## Change Notification

**4M3F Change No.: PCN261011HB**

All FN28x-xx-06 (all single fuse versions)

Change: New fuse holder with extra holder for spare fuse.

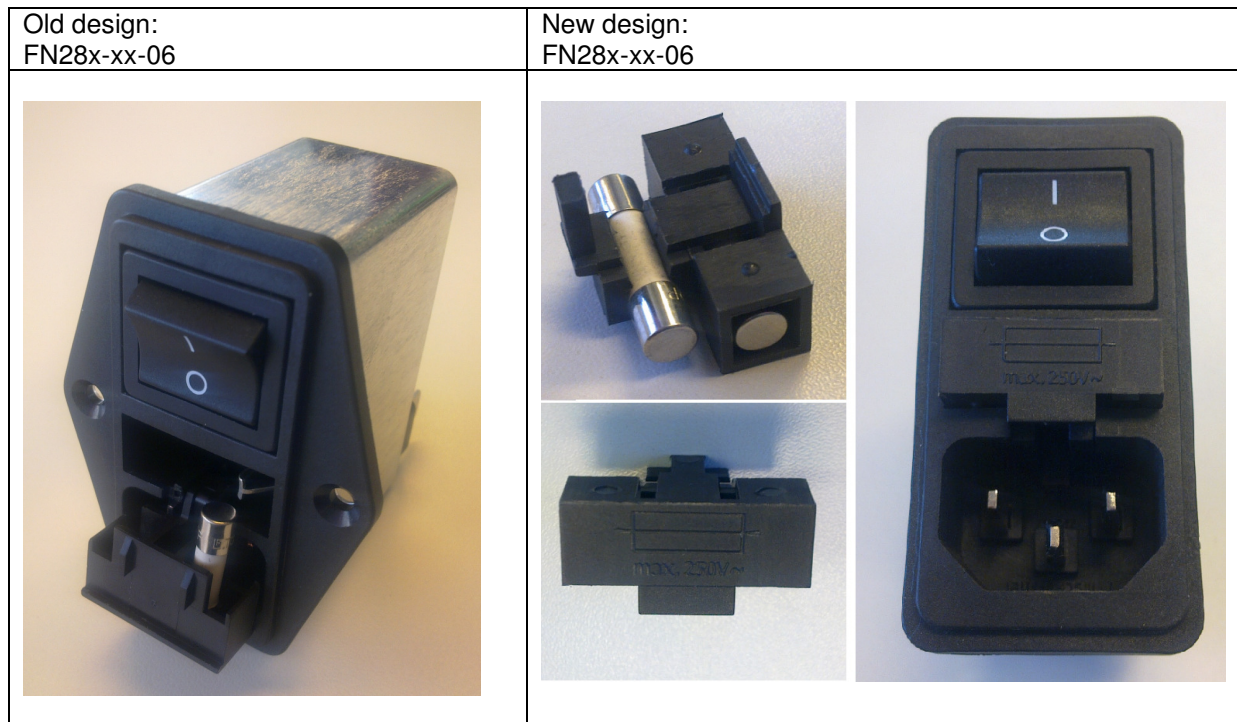
Outer appearance and size remains unchanged. The fuse holder and the internal construction was reworked. It fulfills shock safe category PC2. The fuse holder can be completely pulled out now and contains an extra holder for a spare fuse.

Outside there is no visual difference at the fuse holder.

When pulled out the fuse is now located horizontal across the power entry module instead inward-looking like before (see pictures).
